IFB No. **18-18 Roosevelt & Marshall Reroofing**

RE: **ADDENDUM NO. 2**

Subject: **CHANGES to the BIDDING DOCUMENTS**

Project: **REROOFING PROJECT AT
ROOSEVELT COMMUNITY EDUCATION CENTER AND
MARSHALL ELEMENTARY SCHOOL FOR
ROCKFORD PUBLIC SCHOOLS #205
ROCKFORD, ILLINOIS**

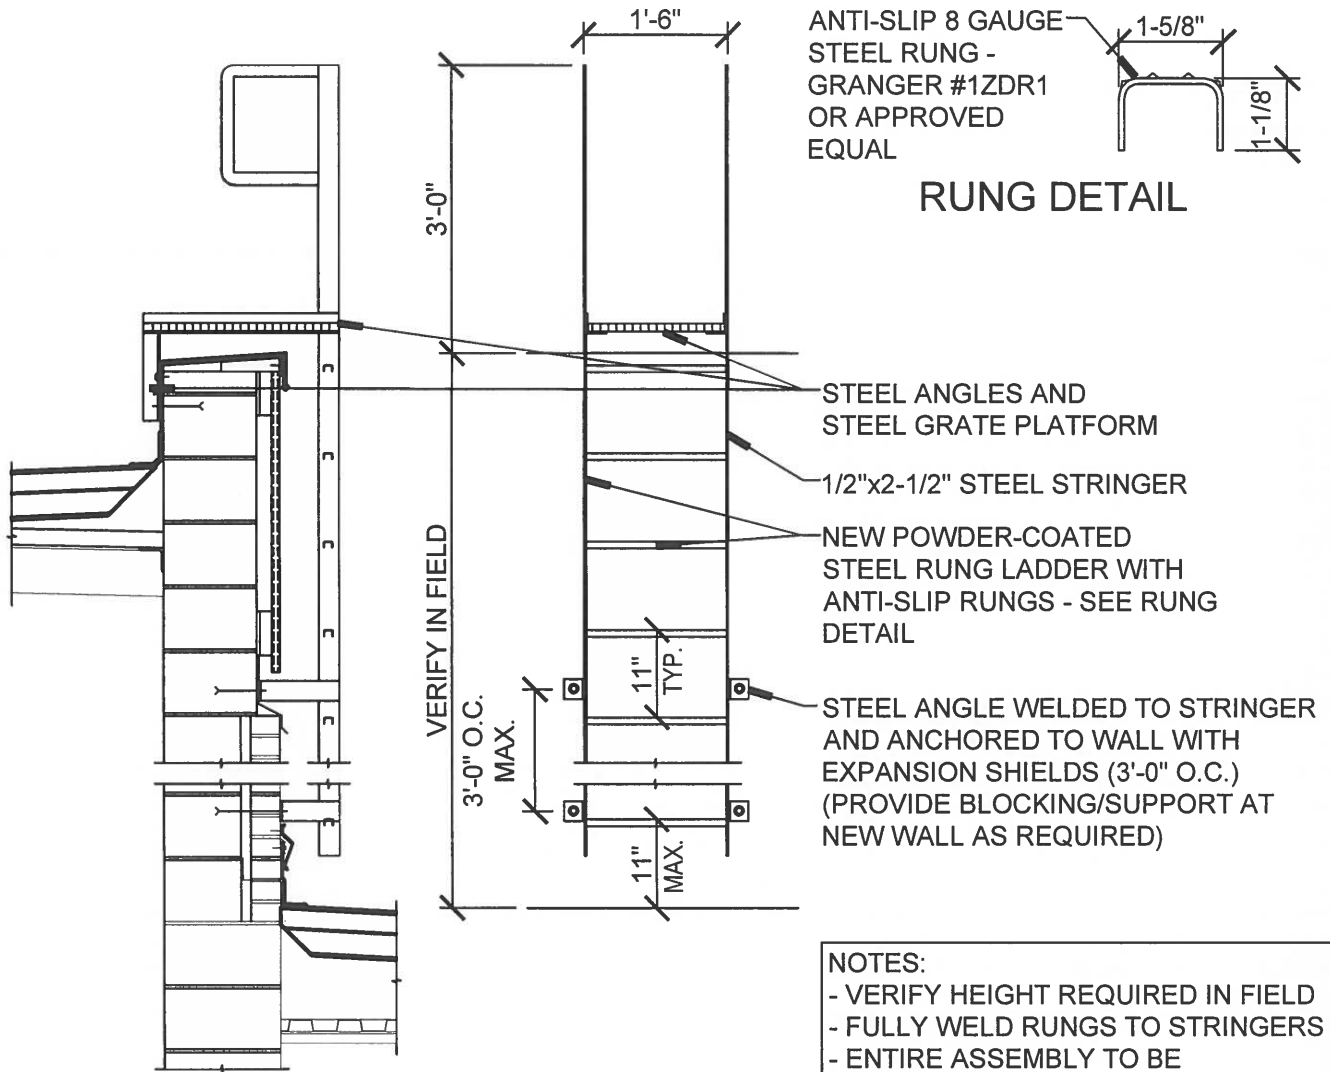
- 2.5.** Question - The drawing call for flashing repairs with "uncured" (I would assume this to mean unsupported) TPO material. Is this correct. TPO flashing are typically from reinforced material.

Answer – The flashings are PVC as mentioned above.

JOB NO. 17-079 ADDENDUM DWG.
 January 31, 2018 **ADA2.1**

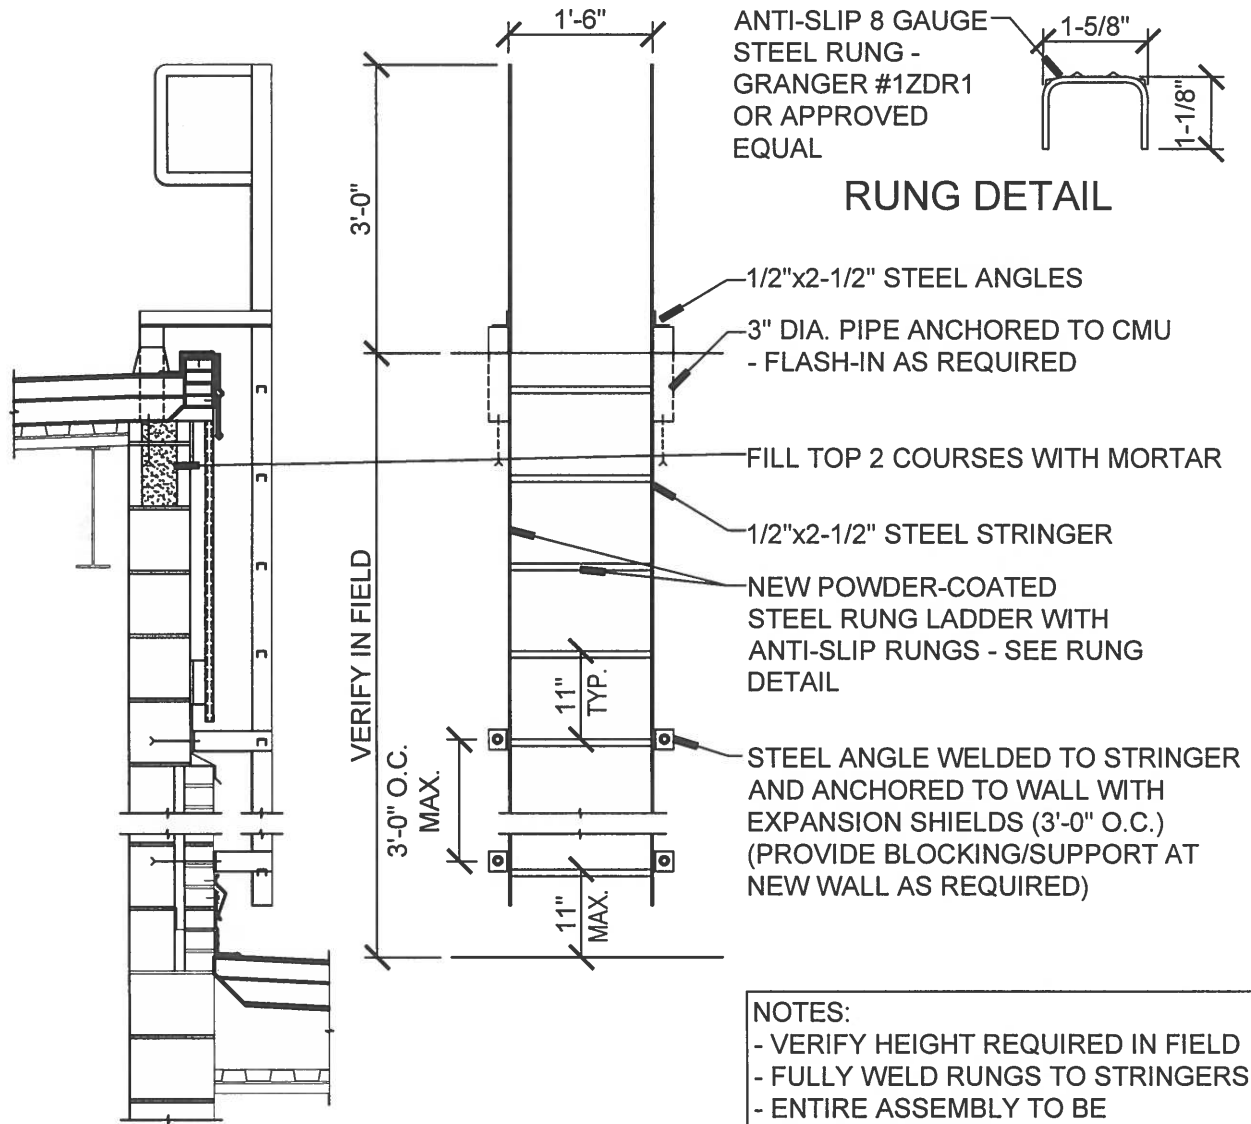
- 1.1.** See attached drawing ADA2.1 showing the revised ladder detail up to the gym roof. Do not anchor supports for the ladder into the existing asbestos panels.
- 1.2.** See attached drawing ADA2.2 showing the revised ladder detail up to the mechanical penthouse roof. Do not anchor supports for the ladder into the existing asbestos panels.

NOTES:
 - VERIFY HEIGHT REQUIRED IN FIELD
 - FULLY WELD RUNGS TO STRINGERS
 - ENTIRE ASSEMBLY TO BE
 POWDER-COATED

JOB NO. 17-079 ADDENDUM DWG.
 January 31, 2018 **ADA2.3**

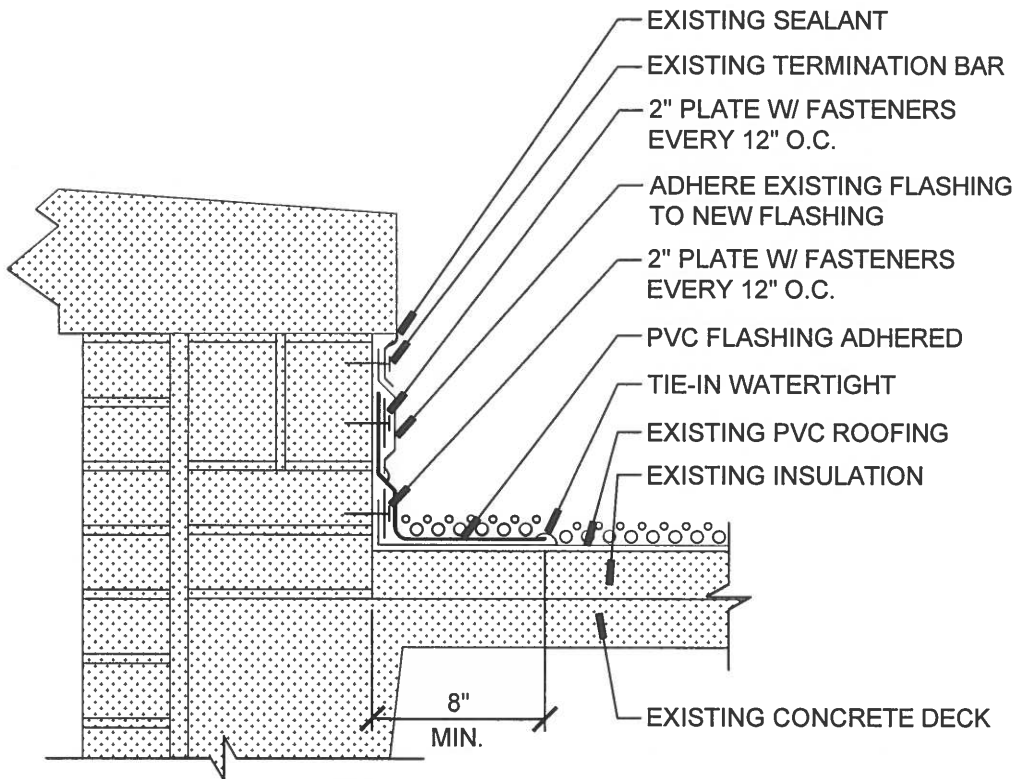
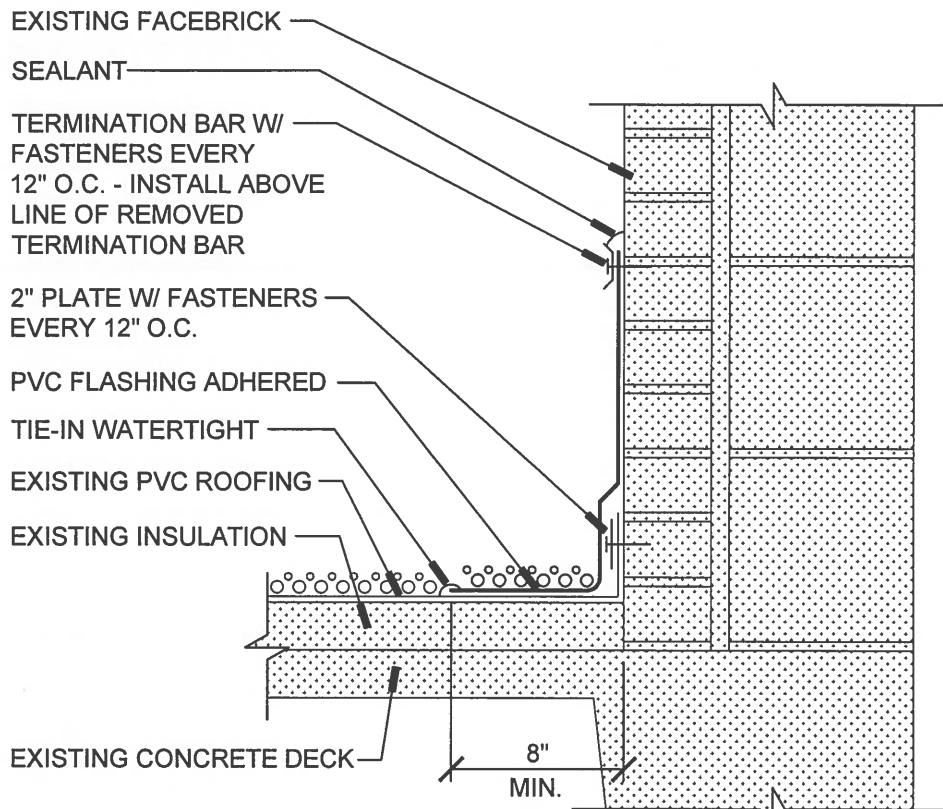
- 2.3.** Question - In the detail I have attached we think the detail drawn would be less chance of a leak. In the detail I have drawn the existing membrane would be used as a counterflashing. Membrane would still be secured in 2 places 12" o.c. We would bring existing membrane over the new membrane that is fastened to wall.

- 3.1.** Details 1 thru 6 - See attached revised drawing ADA2.3 thru ADA2.6 showing revised details.

Answer – See revised details in this addendum.
